SERVICE**BULLETIN****SB #:** F103**BRANDS:****DATE:** MARCH 2010**TO:** ALL AUTHORIZED FERRIS DEALERS

SUBJECT: BLADE INSPECTION - AN INCORRECT ORIGINAL FACTORY INSTALLED BLADE MAY HAVE BEEN INSTALLED ON iCD MOWER DECKS. THE INCORRECT BLADE COULD HAVE A NEGATIVE AFFECT ON CUTTING PERFORMANCE.

Figure 1. Mower Blade Part Number Stamping
A. Mower Blade
B. Mower Blade Part Number Stamping

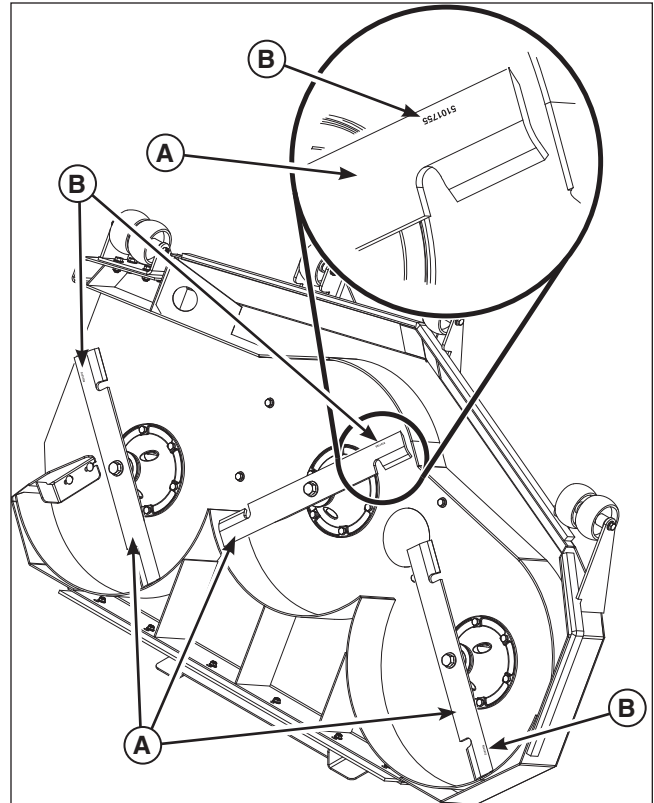
1. Park the machine on a flat, level surface. Disengage the PTO, engage the parking brake, turn off the engine, remove the spark plug wire(s) and wait for all moving parts to stop.
2. Inspect all three of the mower blades for the part number that is stamped into the blade. Refer to Figure 1 for the general location of the part number stamping.
3. Reference the chart below to see if your blade has the correct number stamped into it. **If the mower blade has any other number than what is shown below you MUST perform the CORRECTIVE PROCEDURE.**

Deck Size	Correct Mower Blade Part Number Stamping
52"	5101756
61"	5101755

1. Order and install a new blade set:
 For **52" Mower Decks ONLY** order: 5101756S.
 For **61" Mower Decks ONLY** order: 5101755S.
